**00 91 01
ADDENDUM NUMBER 01**

Project: BL022-26, Forest Valley Water Main Replacement

Addendum No. 01

Addendum Date: February 26, 2026

DRAWING TITLE
WINDSOR FARMS DR
FINAL BACKFILL &
PAVEMENT PLAN

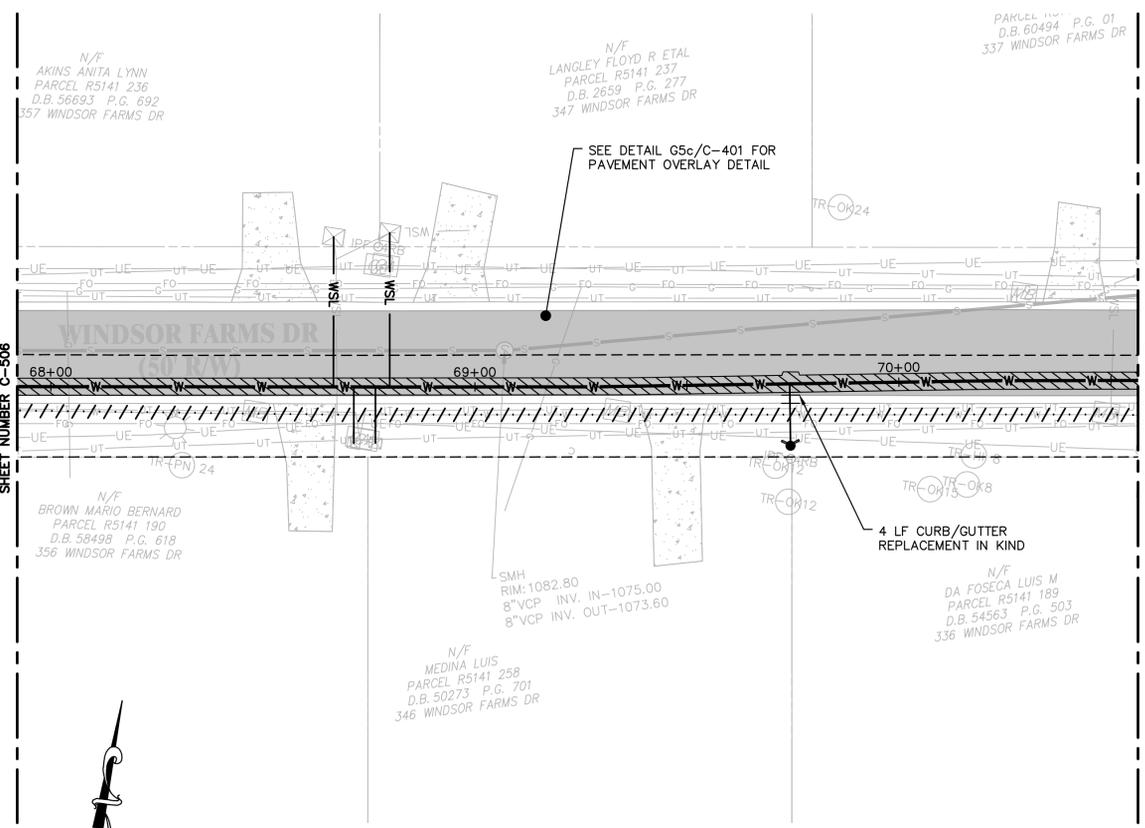
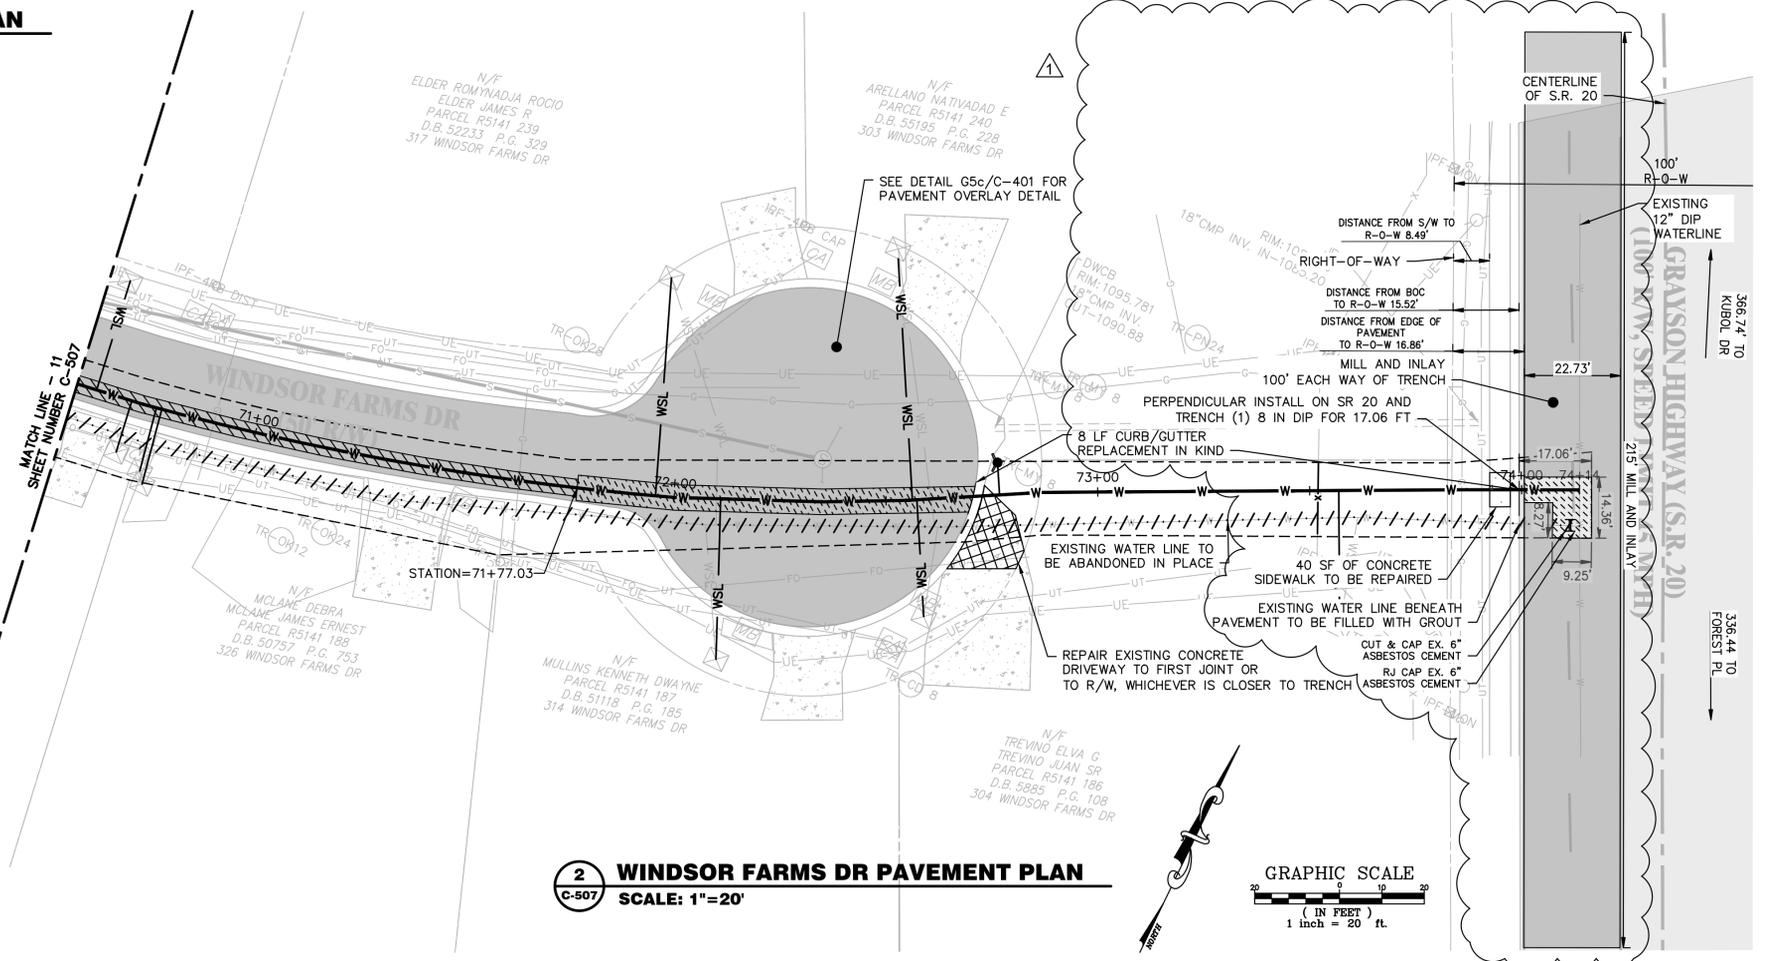
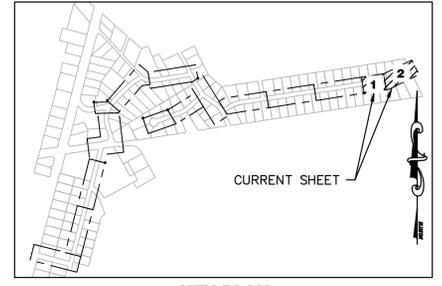
- 6.03 Replacement of concrete sidewalk is called out on sheet C-507. Will a pay item be added for sidewalk installation?
- A. Yes, sidewalk installation pay item has been added to the revised Bid Form Exhibit A (Item No. BB-15). See Article 2 of this addendum.
